Field Report No.: 21											
SP&A Project No: 22.331					Report Date: 1.28.2025		Time: 9:30AM				
Project: Gales Ferry School (Name & Location) 1854 CT-12 Gales Ferry, CT 06335											
General Contractor: The Imperial Company, Inc.											
Weather			Site Conditions			Day of Week					
<input type="checkbox"/> Temp. Range: 238°			<input checked="" type="checkbox"/> Clear			<input type="checkbox"/> Dusty		<input type="checkbox"/> Monday			
<input checked="" type="checkbox"/> Clear			<input type="checkbox"/> Muddy			<input type="checkbox"/> Windy		<input checked="" type="checkbox"/> Tuesday			
<input type="checkbox"/> Overcast			<input type="checkbox"/> Other					<input type="checkbox"/> Wednesday			
<input type="checkbox"/> Rain								<input type="checkbox"/> Thursday			
<input type="checkbox"/> Foggy								<input type="checkbox"/> Friday			
<input type="checkbox"/> Warm								<input type="checkbox"/> Saturday

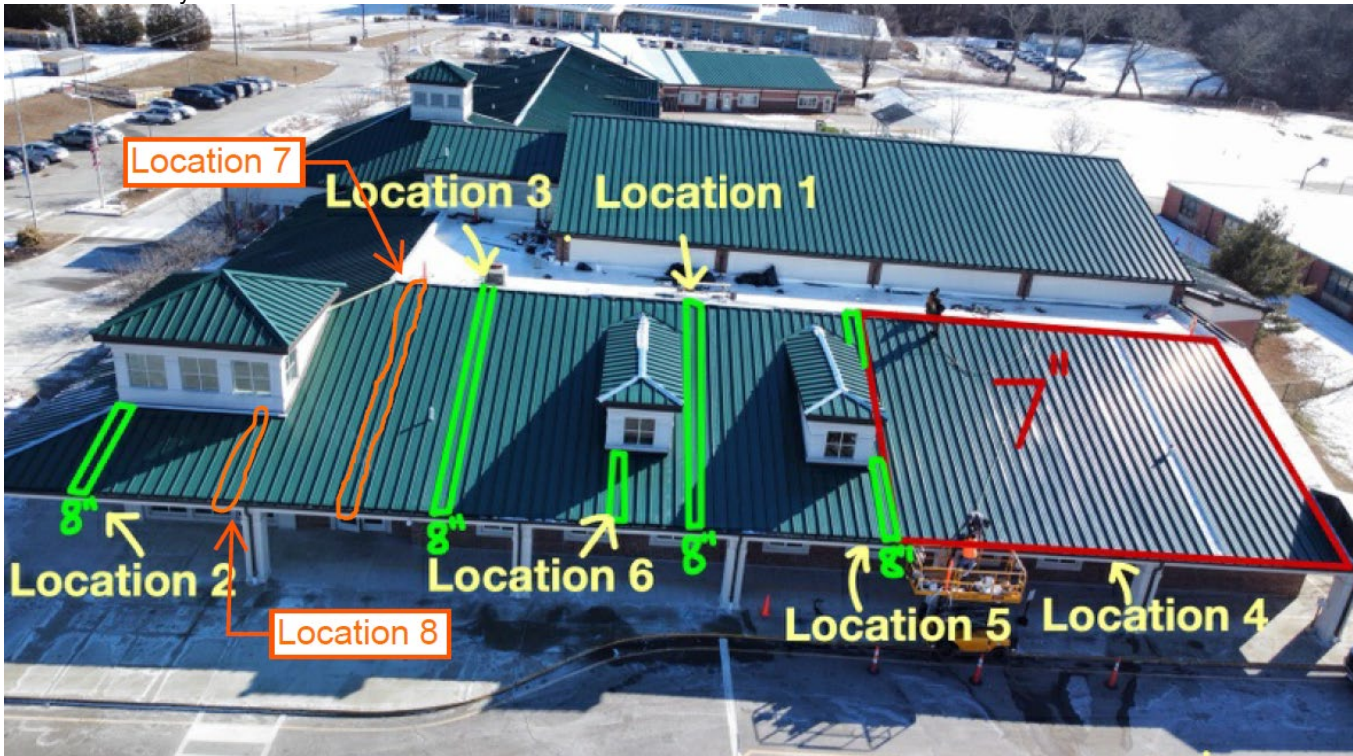
- Past issues that need to be resolved - Panels that were installed and have short screws that need to be replaced need to be observed for the correct screw length by Garland & SPA in areas where the underside decking is not visible. See attached photo.
